STATE OF WASHINGTON
DEPARTMENT OF ECOLOGY

15-NWP-032

Re: Withdrawal of the Proposed September 2014 Permit Modification for the *Hanford Facility Resource Conservation and Recovery Act Permit, Dangerous Waste Portion, Revision 8C, for the Treatment, Storage, and Disposal of Dangerous Waste*, Part III, Operating Unit Group 10, Waste Treatment and Immobilization Plant, WA7890008967

**Modification of the *Hanford Facility*
Resource Conservation and Recovery Act
Permit for the Treatment, Storage, and
Disposal of Dangerous Waste, Part III,
Operating Unit Group 10 (WA7890008967)
Waste Treatment and Immobilization Plant
September 2 – October 20, 2014**

CUSTOMER N/P STAMPING	
HEATER #1	LVP-HTR-000010
HEATER #2	LVP-HTR-000020
HEATER #3	-

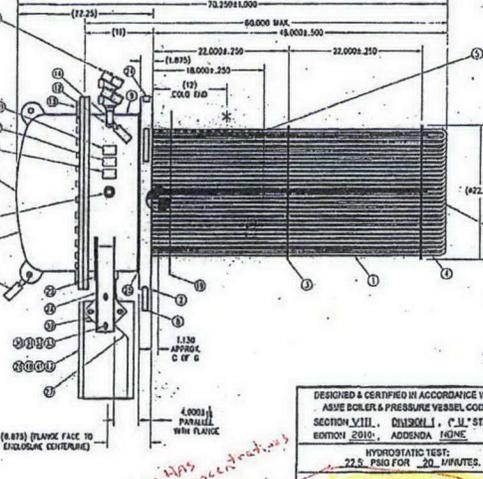
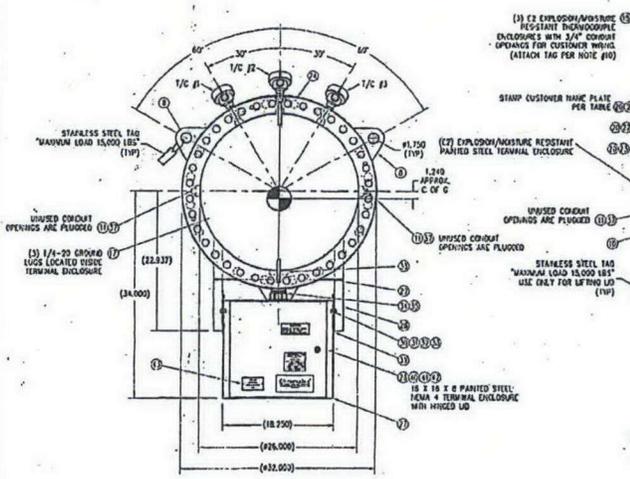
In spite of this the vendor drawings (24590-CD-POA-MEE0-00003-03-0004, Rev 00H and 24590-CD-POA-MEE0-00003-03-0005, Rev 00I) both show in the Design Data Box that the process gas is "air" (not process gas) and each has a check box that is clearly marked that there are no "lethal substances." Contrary to the check boxes, NIOSH has established that the "immediately dangerous to life and health" (IDLH) concentration for NO₂ is 20 ppm_v and the IDLH for NO is 100 ppm_v. The incoming gas to the heaters is therefore more than 285 times the lethal concentration. The vendor did not seem to be aware of this when selecting their equipment. As a result, it may not be fit for hazardous chemical service. The vendor did not list the acid gases or chloride present in the corrosion evaluation either. The NIOSH web page is <http://www.cdc.gov/niosh/idlh/intridl4.html>.

- The Corrosion Evaluation noted on page 1 that type 304-L and Carbon Steel are unacceptable materials. The Mechanical Systems Data sheet indicates this is a Quality Level "Q" procurement. The two vendor drawings provided to Ecology, however, each

only included the first of three sheets. The first sheet notes that the “bill of materials” is located on Sheet #3, which was not part of the package submitted to Ecology. So it is impossible verify if appropriate materials were used or if commercial grade materials were qualified for a “Q” application. Resistance of small parts to the oxidizing environment of the NOx appears to have been ignored, at least in the mechanical systems data sheet. This leaves the construction of the heaters open to question.

Your comment details your concerns related to the Corrosion Evaluation and the Mechanical Data Sheet included in the package. Ecology reviewed the technical and quality control issues documented in your letter. We also discussed these issues with DOE-Office of River Protection (ORP) and Bechtel National Inc. (BNI).

BNI had previously committed to providing to Ecology a revised Process Corrosion Data Sheet (PCDS) with the Corrosion Evaluation submitted with this package. However, Ecology found that the Corrosion Evaluation did not include the latest version of the PCDS. BNI has informed us that the Corrosion Evaluation is being updated with new calculations and will be presented in a new format.
